# Access Compliance Report

## Public Rights-of-Way

Intersection ID: N/A	Main Street: COPPER_WY	Cross Street: N/A	Location: SE
ADA ID: 4BF9EA19C261	Ramp Type: Perp	Initial Pass/Fail: Fail	Overall Compliance: No
Codes/Mitigation Info/Possible Solution		Field Measurements/Component Compliance	
Severity Score: 1.25

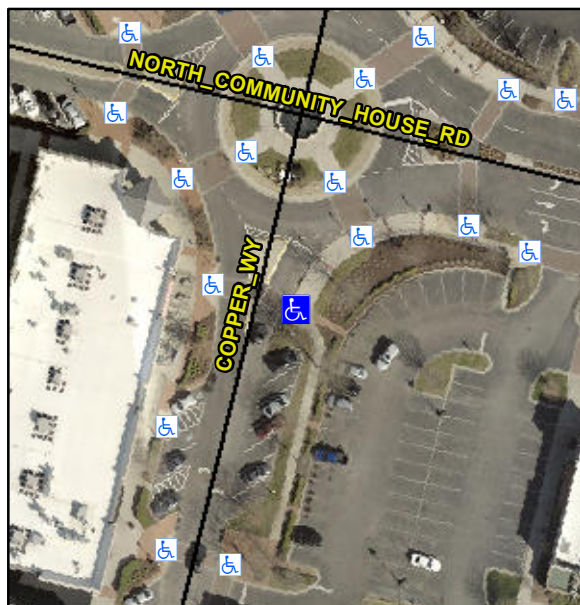
**R304.5.3**

Compliance	Description	Data	Compliance	Description	Data
N/A	Ramp Length (in)	142.0	Yes	Ramp Slope (%)	6.6
Yes	Ramp Width (in)	113.0	No	Ramp XSlope (%)	3.6
N/A	Flare Type LT	N/A	N/A	Flare Type RT	N/A
N/A	Flare Slope LT (%)	N/A	N/A	Flare Slope RT (%)	N/A
N/A	Flare Traversable LT?	N/A	N/A	Flare Traversable RT?	N/A
N/A	Landing Length (in)	N/A	N/A	DWS Provided?	N/A
N/A	Landing Width (in)	N/A	N/A	DWS Contrast?	N/A
N/A	Landing Slope (%)	N/A	N/A	DWS Length (in)	N/A
N/A	Landing X Slope (%)	N/A	N/A	DWS Full Width?	N/A
N/A	Landing Curb? (Y/N)	N/A	N/A	DWS Offset (in)	N/A
N/A	Shared Landing?	N/A			
N/A	Gutter Ponding?	N/A	N/A	Gutter Slope (%)	N/A
N/A	Gutter Lip Ht (in)	N/A	N/A	Gutter X Slope (%)	N/A
N/A	Painted X Walk1?	Yes	N/A	Painted X Walk2?	N/A
	X Walk 1 Direction	To W		X Walk 2 Direction	N/A
N/A	X Walk 1 Width (in)	103.0	N/A	X Walk 2 Width (in)	N/A
	X Walk 1 Slope (%)	5.7		X Walk 2 Slope (%)	N/A
	X Walk 1 X Slope (%)	0.2		X Walk 2 X Slope (%)	N/A

**Remove & Replace Entire Ramp.**
